# ProtectLink Dual-Band 700/800 DAS ORU Model Numbers

# **Software Release Notes**

Document Number: CS40-734834-00D-AR/CS40-734834-00D-BR

Revision: 6.00

#### 700/800 ORU Loss of AC Power Relay (Alarm modification needed) MOP

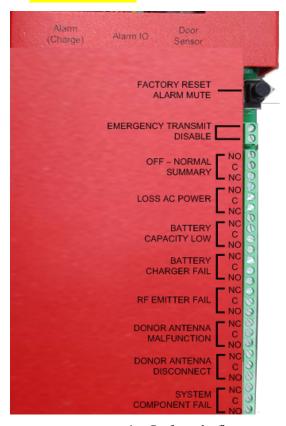
Background: Defaulted the AC Power Fail and OFF-Normal Summary output relays to 1 which
Software Release Notes: CS40-xxxxxx-00D-AR
Rev: 6.00

is the charged state. On alarm those relays are now set to 0 or the uncharged state. This allows the relays to indicate failure on complete loss of power by switching the NO and NC contacts.

- 1. Note the current version
- 2. Sign into GUI and mask all alarms on all devices from the Alarm GUI screens
- 3. If current version is pre 2.00.21, the following output relays MUST be RE-WIRED according to the diagram below:

OFF - NORMAL SUMMARY LOSS AC POWER

- 4. Perform the firmware upgrade from the System Settings GUI screen.
- 5. Unmask all alarms on all devices from the Alarm GUI screens.
